SUBJECT: Benedictine Monastery Planned Area Development (PAD-37), Minor Amendment – Relocation of Monastery cooling tower and existing chiller.

RE: Minor Amendment to Benedictine Monastery PAD

THE BENEDICTINE
HISTORICAL RENOVATION
50% CONSTRUCTION DOCUMENT SET 11.13.20
800 N COUNTRY CLUB RD, TUCSON, AZ 85716
B-G102 CHILLER LOCATION
DIAGRAM

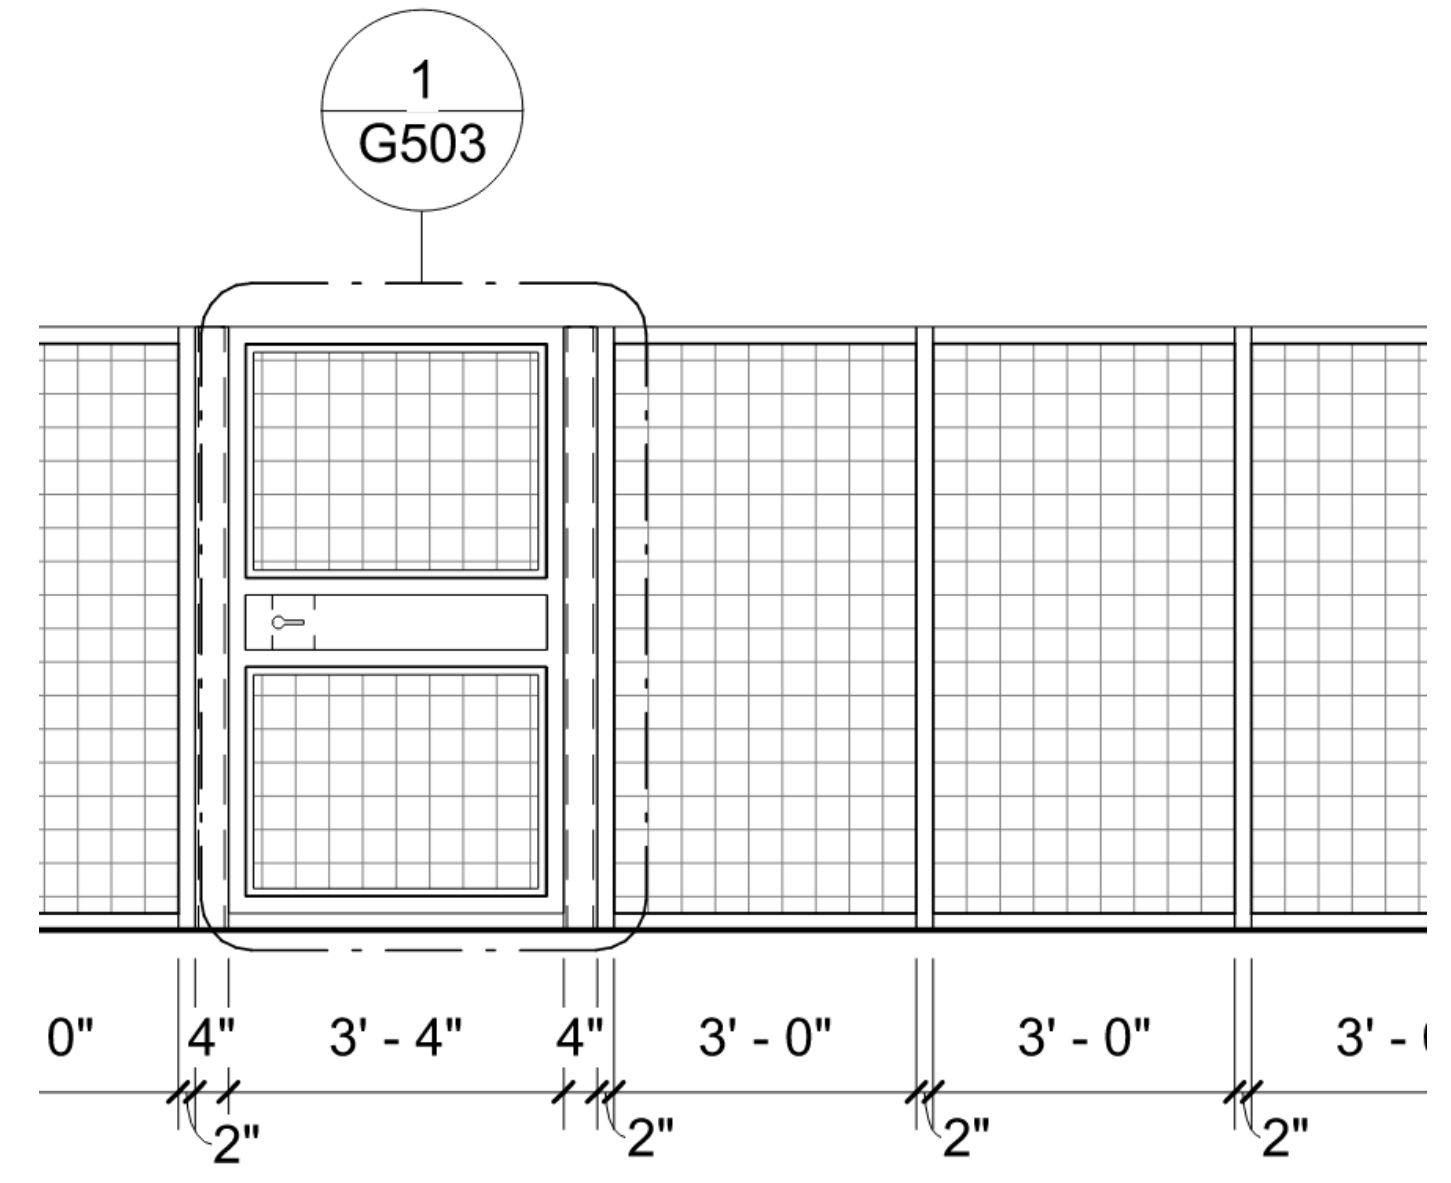
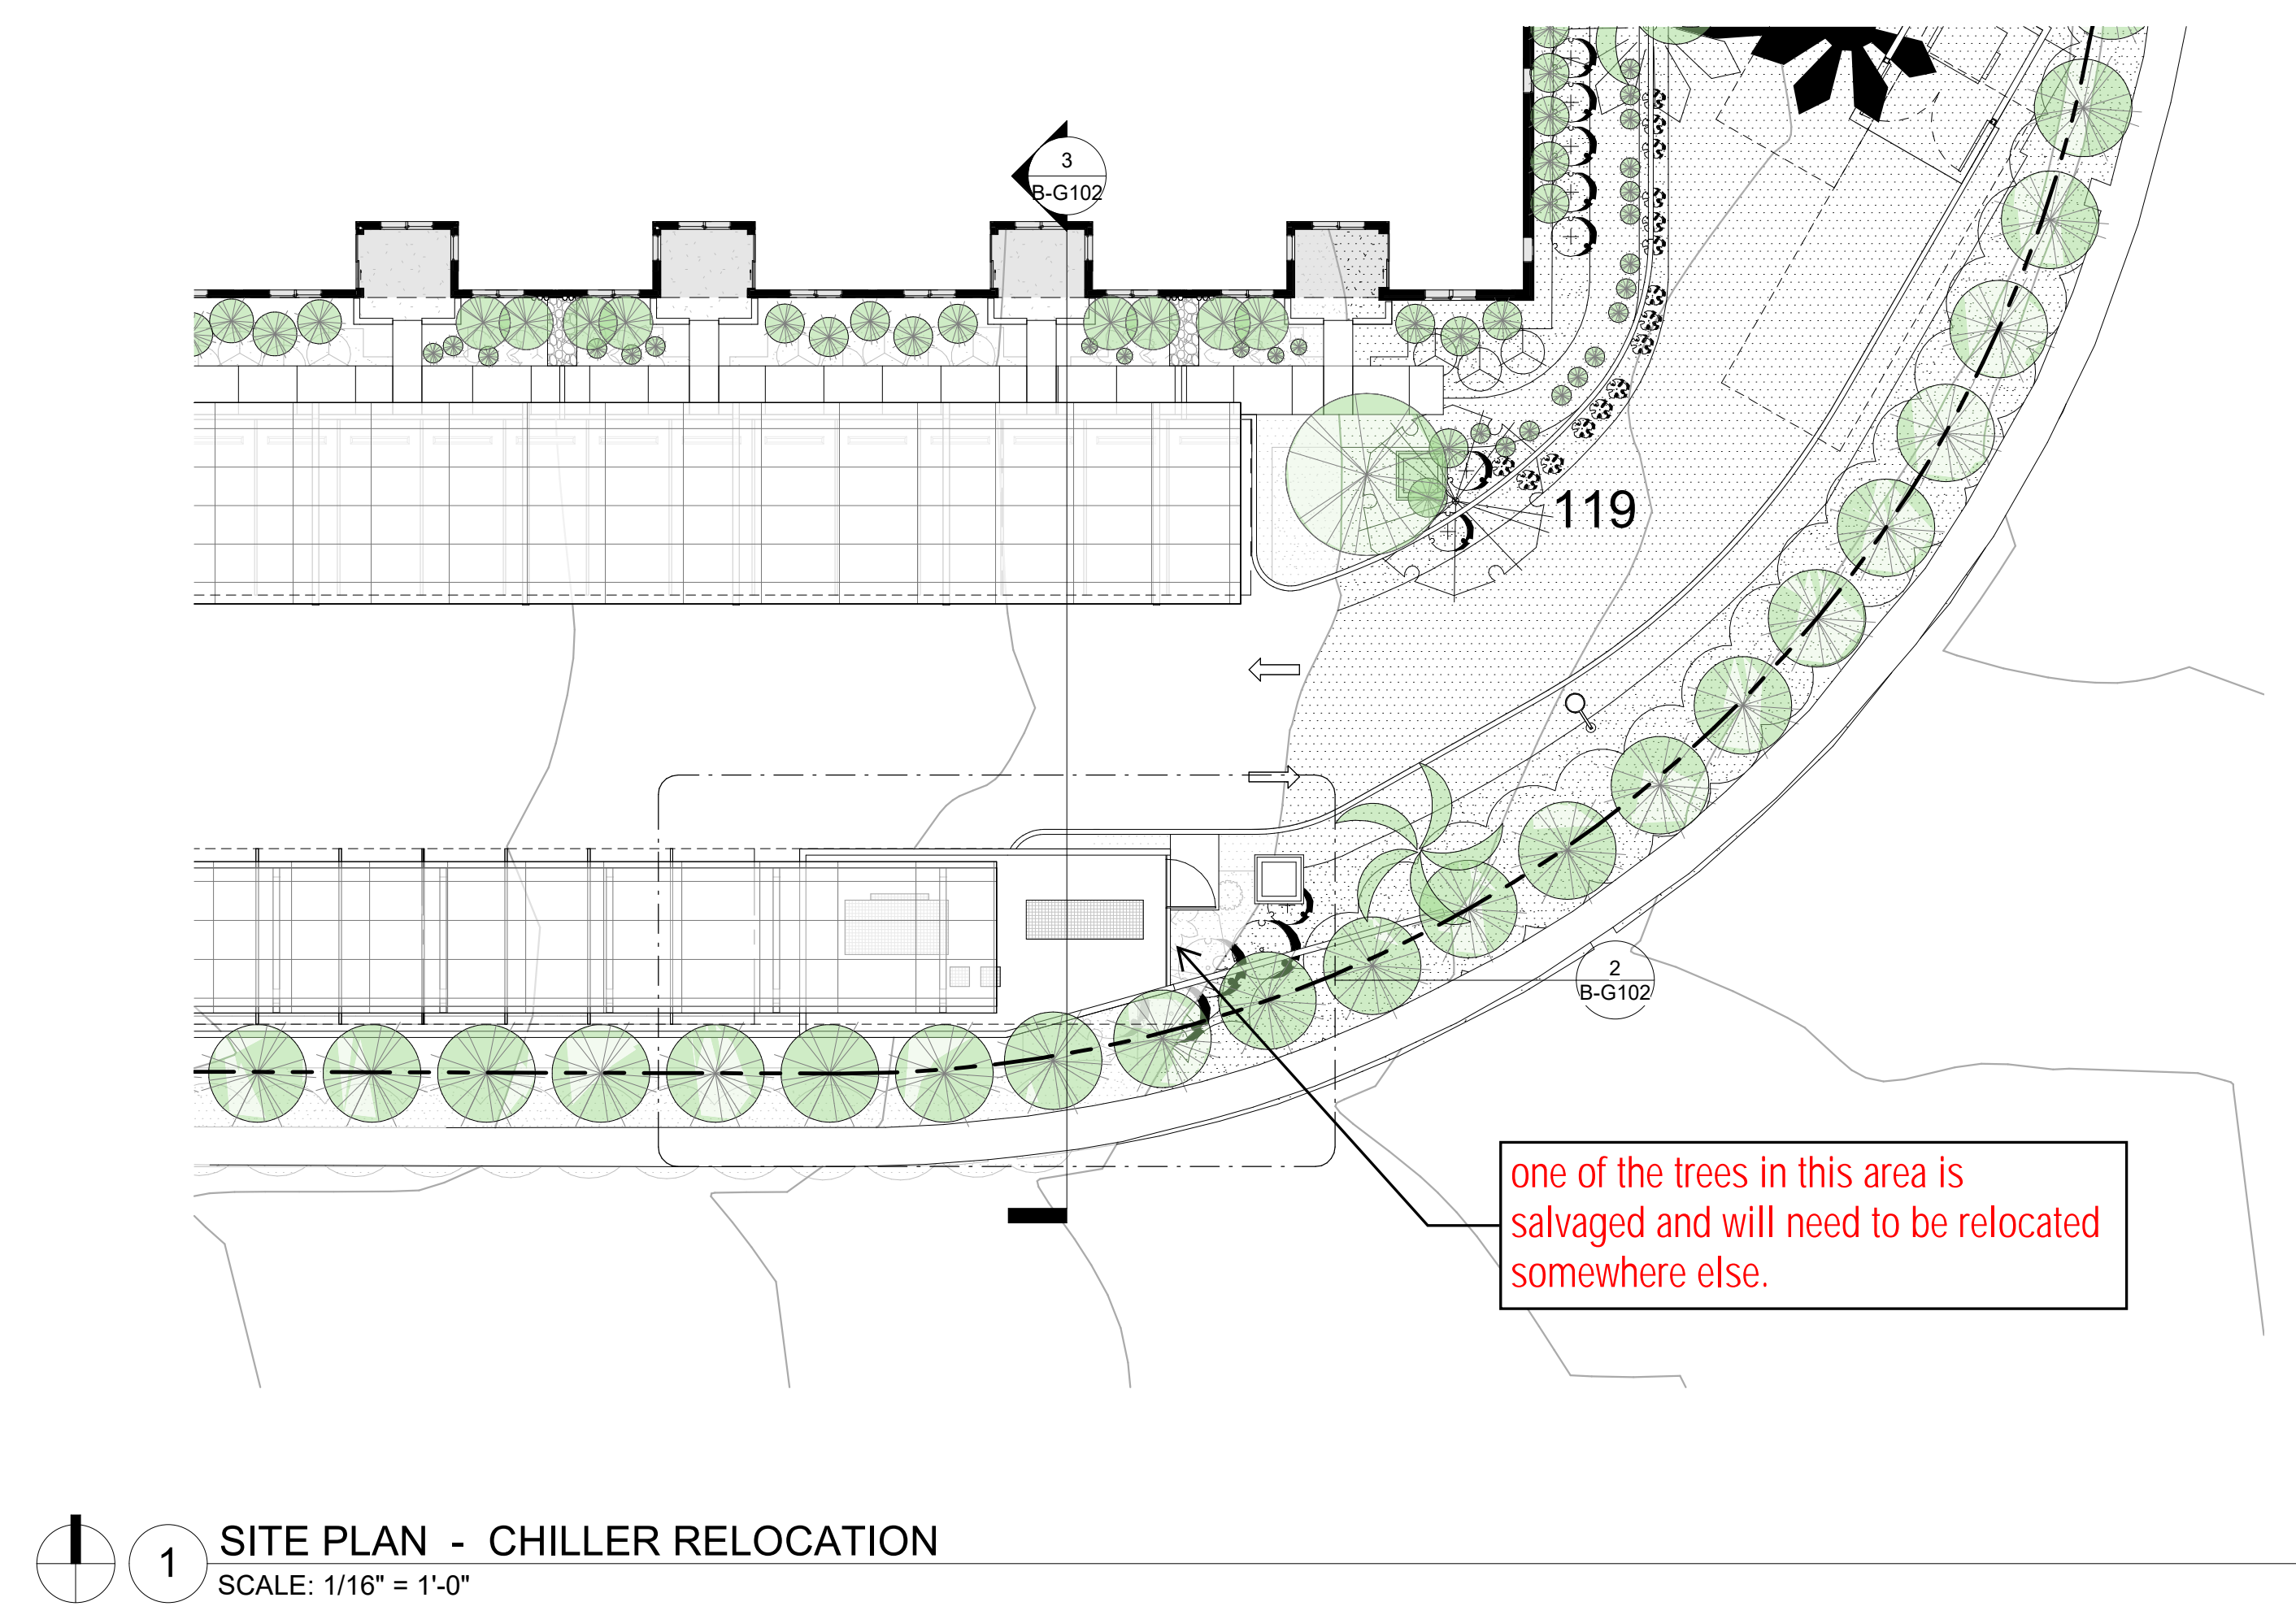
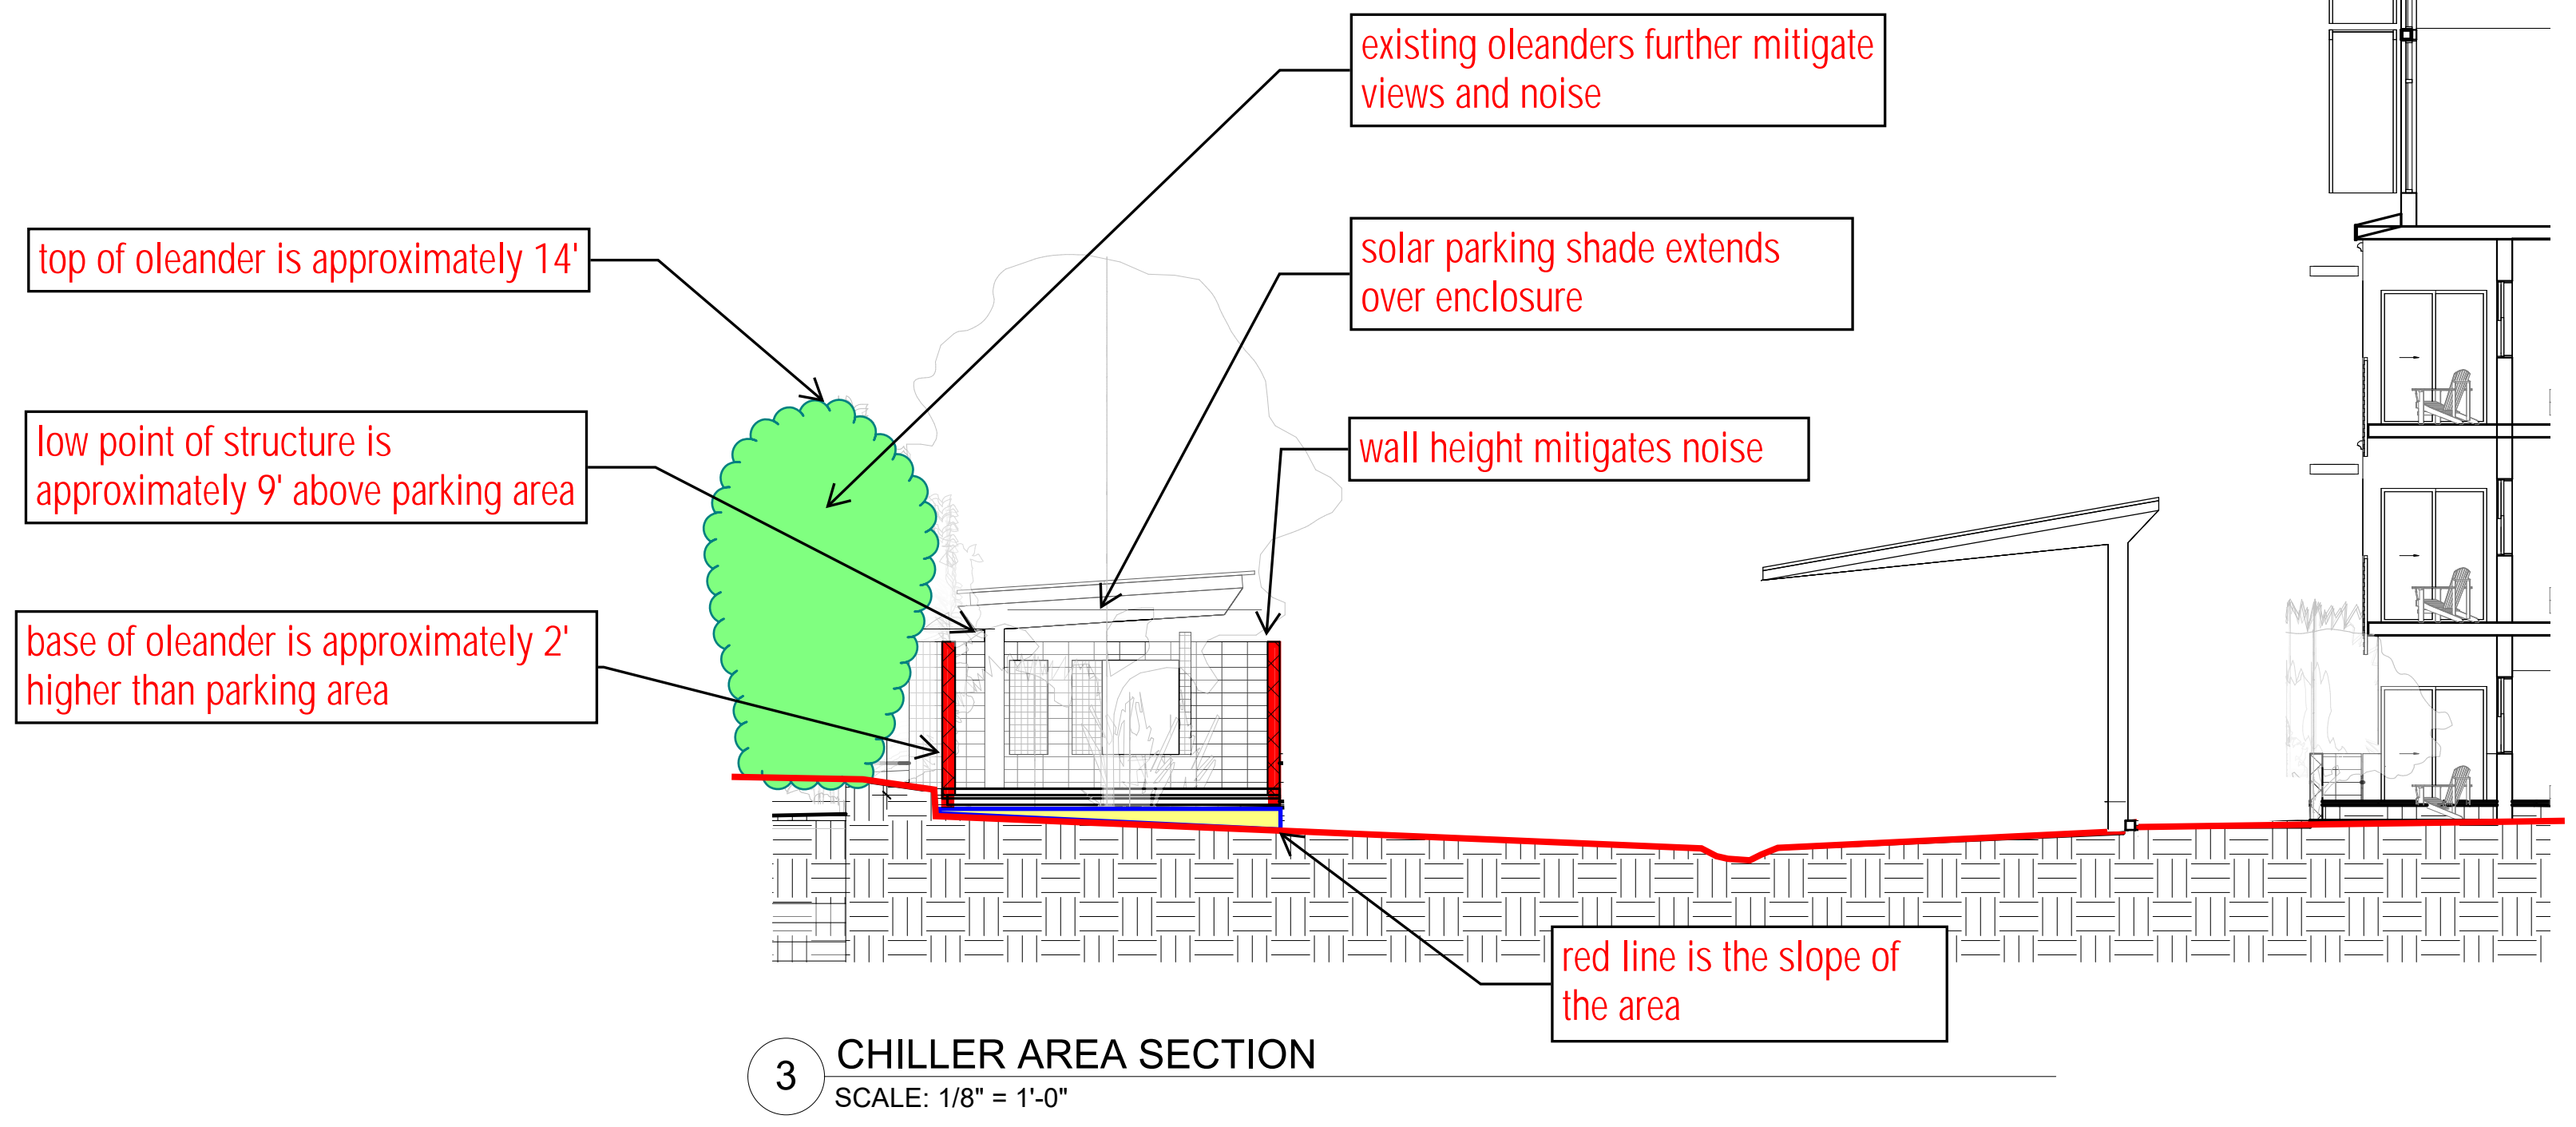
Attached is a PDF that details the location, dimensioned cross-section, and rendering of this new proposed Cooling Tower/Chiller enclosure. The chiller fits below and is shaded by the extension to the parking shade/solar panel structure.

- The chiller itself is located under the extension of a specifically entitled steel shade/solar structure with a height of 9' on the southern end and 10' at the PAAL to the north.

- The chiller itself is approximately 6' tall, lower than the 8'-0" wall that surrounds it. That 8'-0" wall in turn is 2'-0" below grade at its southern end

- The cooling tower is not under the extension of the steel shade/solar structure because it needs access to the air above it. But it too is lower than the surrounding CMU wall.

- The utility enclosure is made of integral colored masonry on the south, west and north sides. This masonry matches the other utility enclosures and the lower portion of the building itself. The east side is made of welded wire fabric to allow gate access from the east.
